Access Compliance Report

Public Rights-of-Way

Intersection ID: 46144	Main Street: EASTFIELD_VILLAGE_LN	Cross Street: ROCKY_FORD_CLUB_RD	Location: E
ADA ID: 8FBE9EC9FC34	Ramp Type: BlendTrans1	Initial Pass/Fail: Pass	Overall Compliance: No
			Severity Score: 15

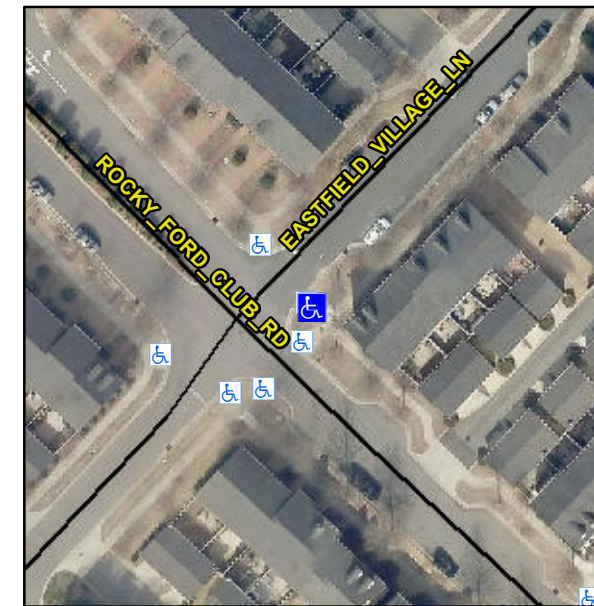
Remove & Replace Curb Ramp With Two New Directional Ramps or Equivalent. Grind Gutter Lip.

R304.2.2-Perp, R304.3.2-Para, R305.2, R302.7.2
